ATTACHMENT (1)

BACKGROUND AND ANALYSIS

This submittal documents the Calvert Cliffs SFP Rack Criticality Methodology that was used to ensure k-effective for the Unit 2 SFP is less than the 10 CFR 50.68 regulatory limit for VAP fuel. The soluble boron credit will be limited to 300 ppm per the restrictions of the Unit 1 criticality analysis documented in Reference (1). Note that 300 ppm is a minimum boron concentration requirement. The proposed change to Technical Specification 4.3.1 adds approximately 15 percent to this value to account for any unknown uncertainties. This increases the boron level to 350 ppm required to safely store 5.0 weight percent VAP fuel in the SFP.

FORM 19, CALCULATION COVER SHEET

Figure 8: Enrichment vs Burnup

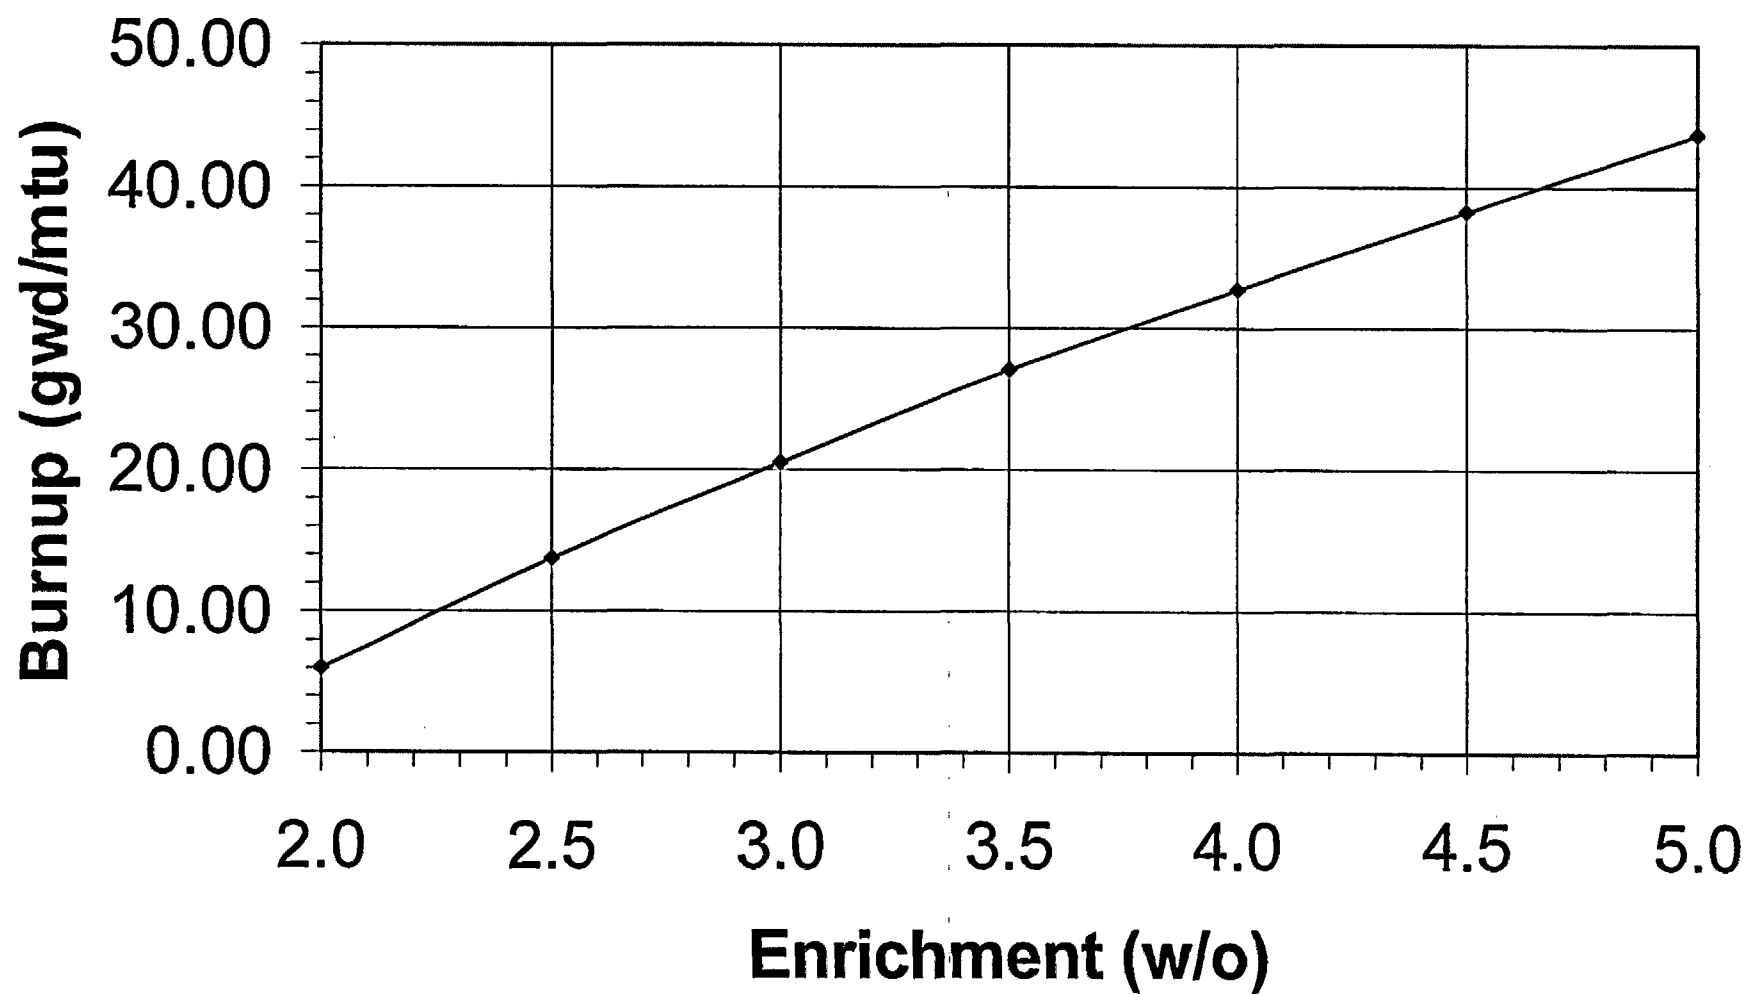
(21) Section 9.D. In the paragraph just below the table, the first sentence indicates that Figures 8 – 11 depict various isotopic quantities as a function of burnup. This needs to be changed to Figures 9 – 11. Figure 8 looks like a loading curve but it could use a better title since the current one is not very descriptive.

Response: Done
